FRISENHAHN MASTER DEVELOPMENT PLAN

Re: Friesenhahn (Amendment)

MDP# 802-A

The City Staff Development Review Committee has reviewed Friesenhahn (Amendment) Master Development Plan M.DP# 802-A, please find enclosed a signed copy for your files. Your plan was accepted however please note the following:

TYPICAL STREET SECTION (85' ROW)
SECONDARY ARTERIAL
(NOT TO SCALE)

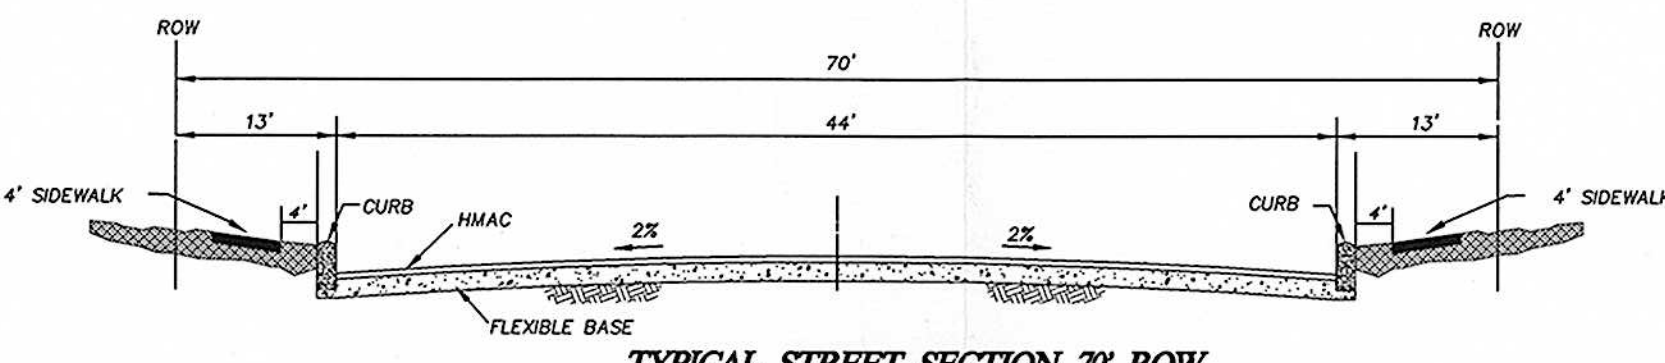
1. The above referenced MDP is approved with the following condition: Remove all specific reference to pavement structure on the secondary arterial typical street section. Utilize generic labeling for surface course, base course and subgrade.

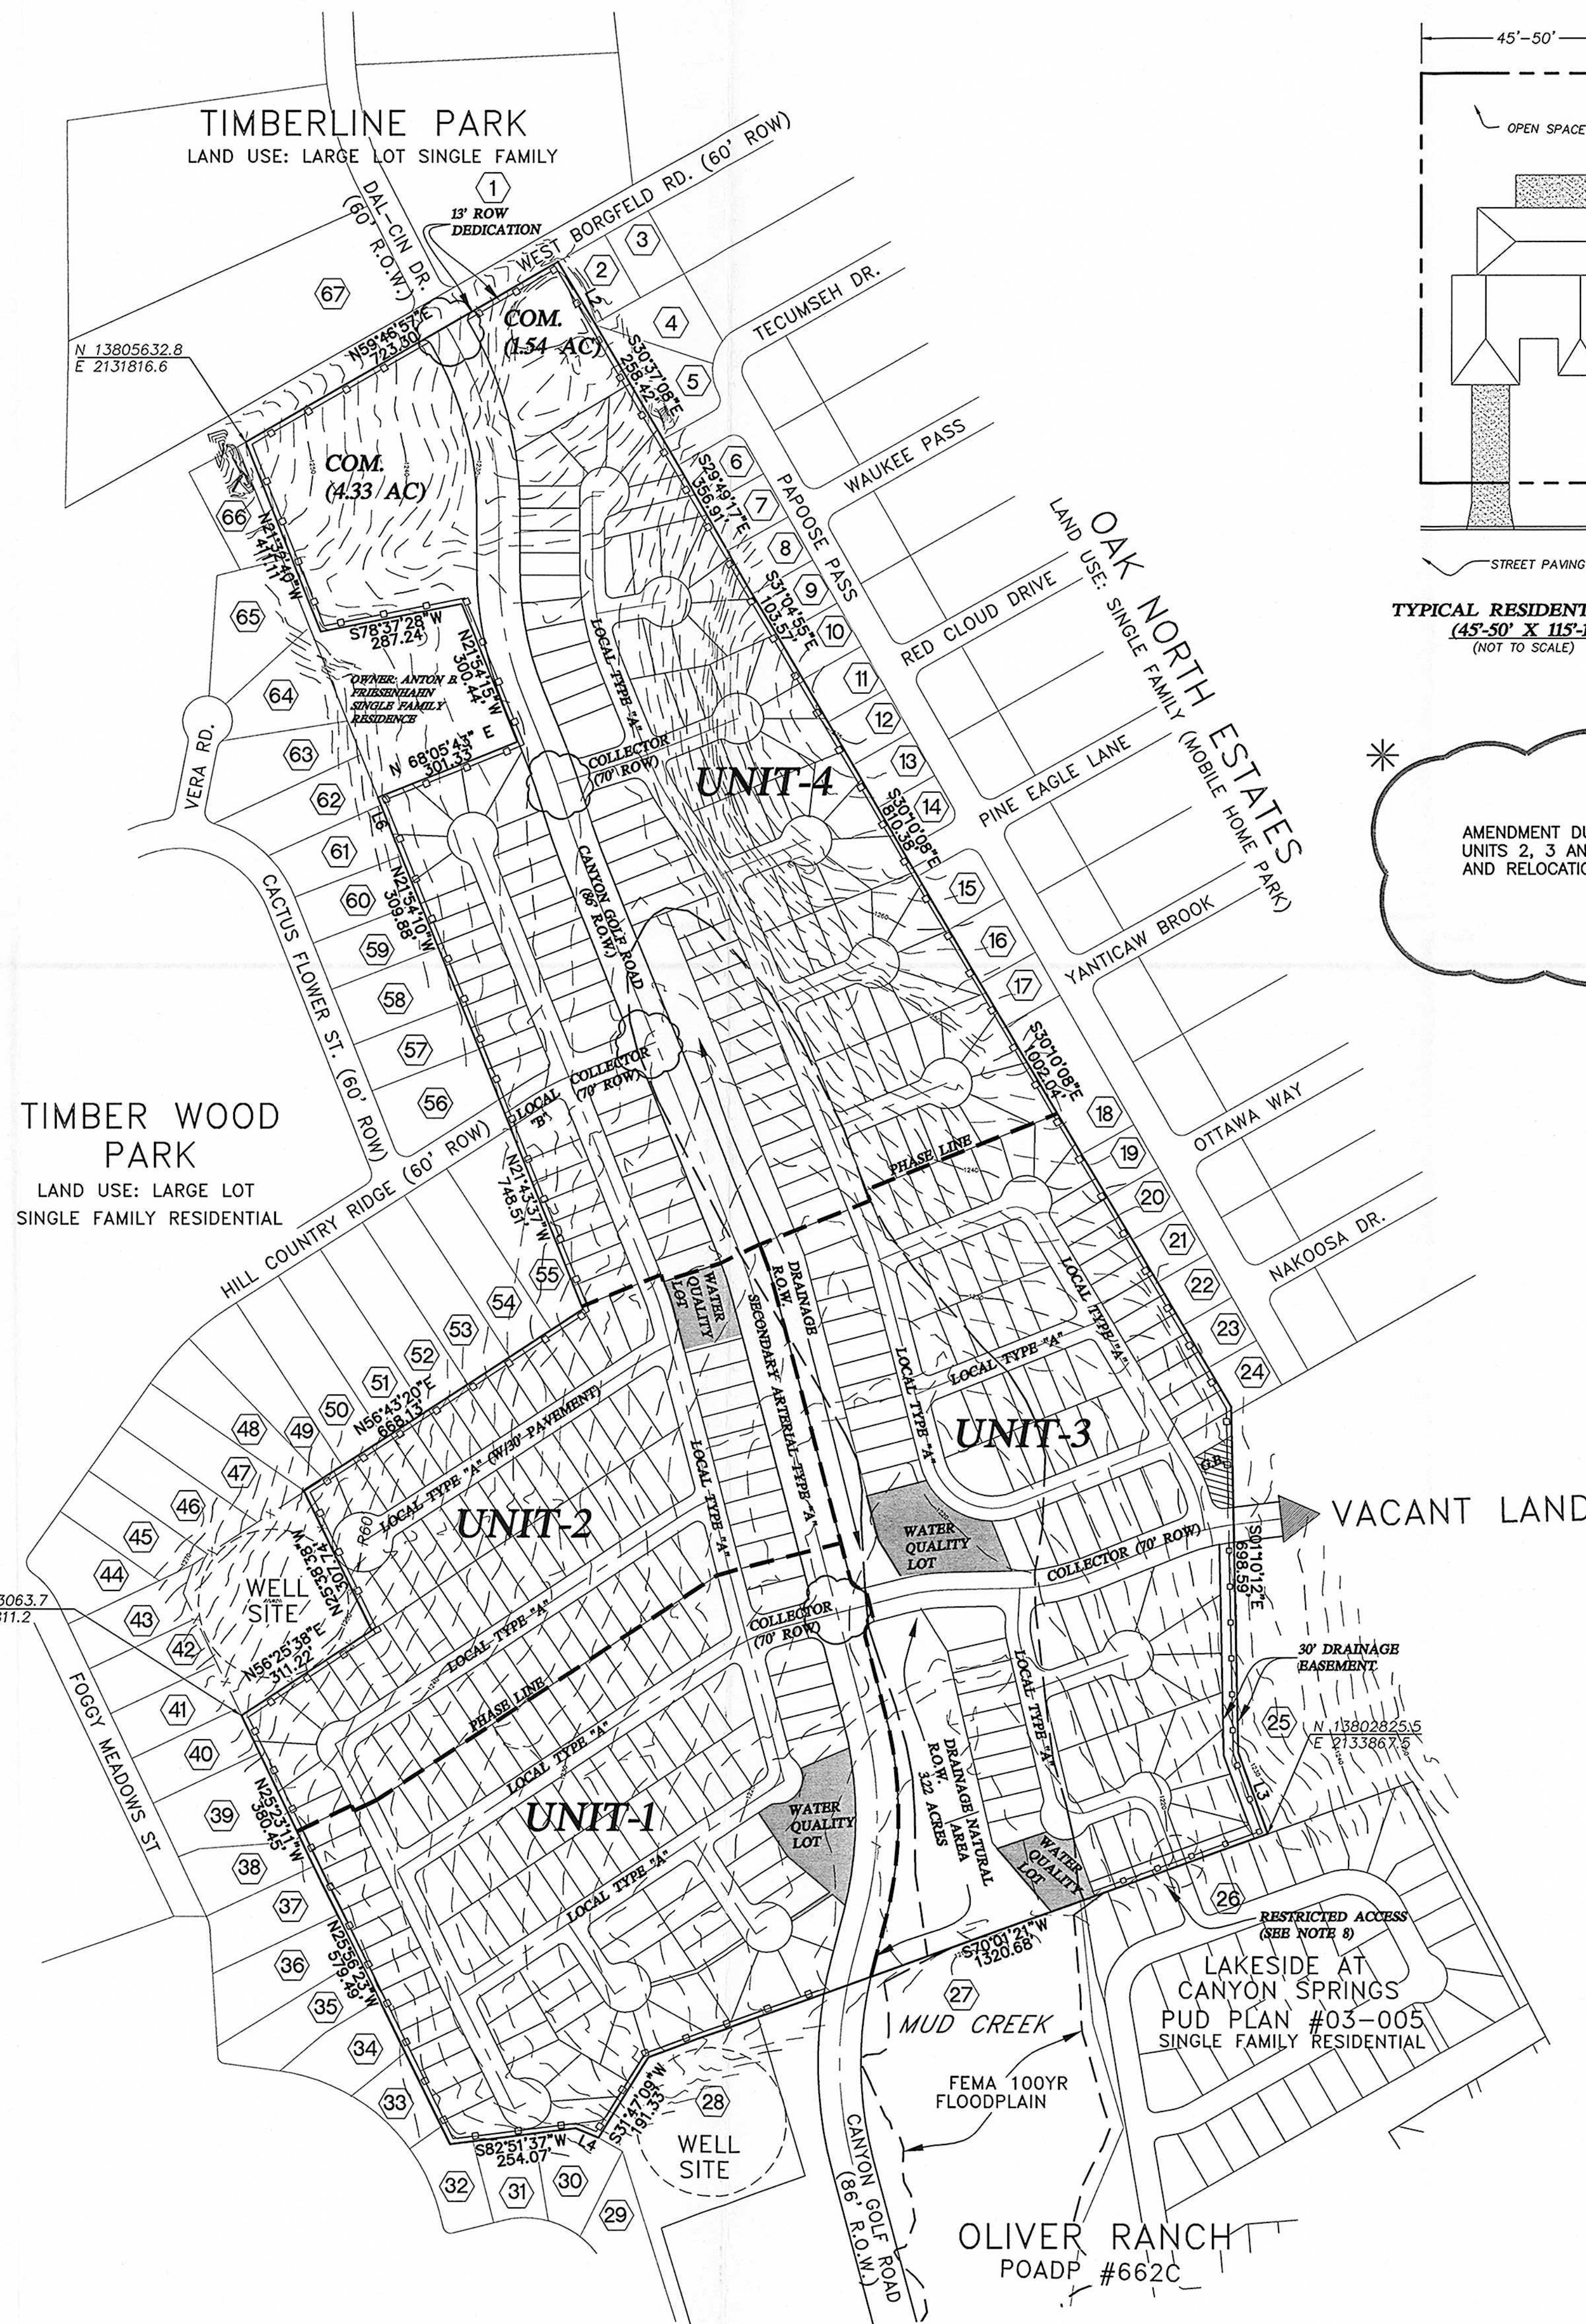
2. The following issues should be addressed during the respective platting process:
 - a. Evaluate the potential need for drainage interceptors with easements in the southeast corner and along the midwest boundary of the development.

- b. Evaluate potential street grade issues on several cul-de-sacs in the northeast sector and on the northern portion of Canyon Golf Road.
 3. It should be understood that this is a general review of a conceptual plan and that *all* technical requirements of the Unified Development Code for Streets & Drainage shall be complied with.
